CU24-06 853 W. Fifth St., Lots 16 & 17 Thayers Park Front Addition, H.D. Mize Rentals, LLC, Applicant, requests a Conditional Use approval for 2 three-unit multi-family dwellings and a variance to reduce the required number of parking spaces to a total of 9 spaces, zoned RU Residential Urban, .28 acres +/-

CONDITIONAL USE FINDINGS: For two three-unit multi-family dwellings.

VARIANCE FINDINGS: Reduction of the required number of parking spaces to a total of Nine. Section 155.093 (B) of the Zoning Ordinance of Greenfield addresses variances from development standards. "The Board of Zoning Appeals shall approve or deny variances from the development standards (such as height, bulk, or area) of the Zoning Code, unless already heard by the Plan Commission during the platting process. In approving variances, the Board of Zoning Appeals may attach such conditions to the variances as it deems necessary to assure compliance with the purpose of the Zoning Ordinance. If the conditions of the variance are not completely and continuously adhered to after the granting of the variance, the property and/or owner may be subject to enforcement actions and revocation of the terms of approval. A var

Project Name:	HD MIZE
Sheet Title:	PLOT PLAN

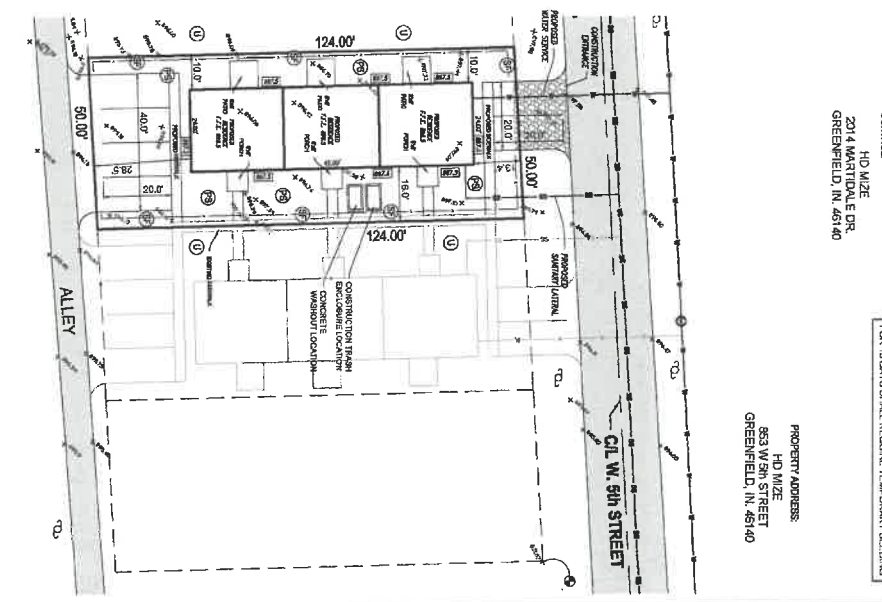
Findings: The petitioner proposes to improve the site with nine parking spaces on the rear of the property along the alley. The UDO requires 1.5 spaces per unit; therefore, the proposed number of spaces is one short of the requirement. The petitioner is requesting a variance to allow a reduction of the parking requirement to a total of nine spaces.

Per the Residential Urban section of the UDO the “Parking lots shall be screened with a brick or masonry opaque wall of at least three feet in height or landscaping of a similar mass”. The petitioner has stated that they will install the landscaping screen on the east and west property lines. A landscaping plan for this screen, done by a landscape architect, will need to be submitted with the plans for permitting.

The neighborhood in which this site is located does not have curbs and sidewalks. The city engineer has reviewed the site and has waived the requirement for a sidewalk along the street.

Findings: The site will have screening of the parking area mentioned above. Two street trees will also be required and installed per Section 97.03 of the municipal code or ordinance.

1. Complete the platted lot combination using the specific language required per Section 155.080 of the UDO.
2. Provide a revised site plan with the nine parking spaces on the rear of the lot prior to permitting.
3. A landscaping plan for the parking lot screening, done by a landscape architect, will need to be submitted with the plans for permitting.
4. Install two street trees in accordance with Section 97.03 of the municipal code or ordinance.
5. All required permits be obtained.
